Office Action Summary

10/607,138

HACK ET AL.

DETAILED OFFICE ACTION

FIG. 1

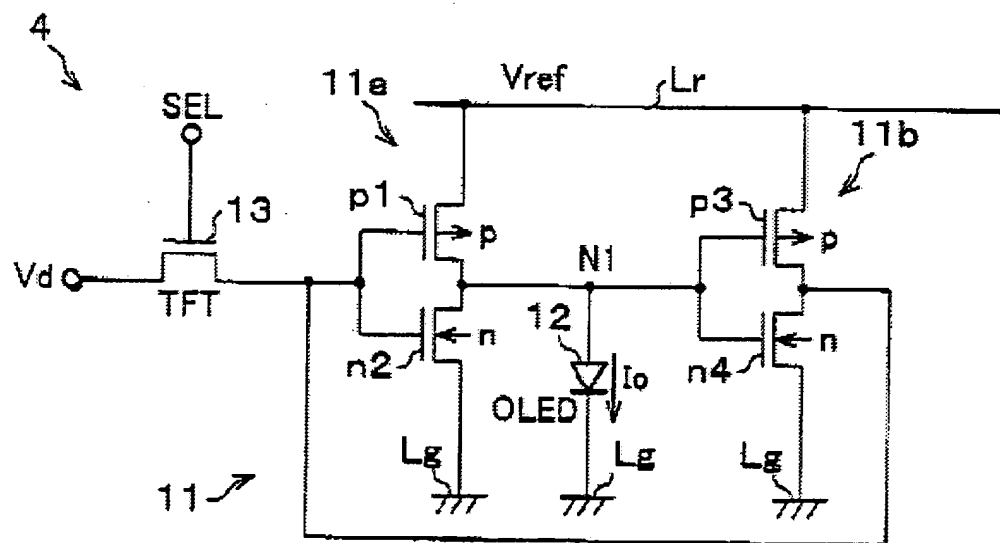
Okamoto (the abstract, fig 1,fig 16, paragraph [0091] discloses a device, comprising: a pixel having a plurality of bistable subpixels { fig 16 reference 4-1 4-2,) each subpixel having an ON state and an OFF state; a plurality of power lines (fig 1 lines Vref and Vd,) wherein a different power line is coupled to each bistable subpixel; and circuitry connected to the plurality of power lines, wherein the circuitry is capable of individually controlling a power signal

transmitted through each power line; wherein each subpixel includes a light emitting device (fig 1 element 12) that emits light when the subpixel is in the ON state; and wherein each subpixel has substantially the same size and emits substantially the same spectrum of light in the ON state.
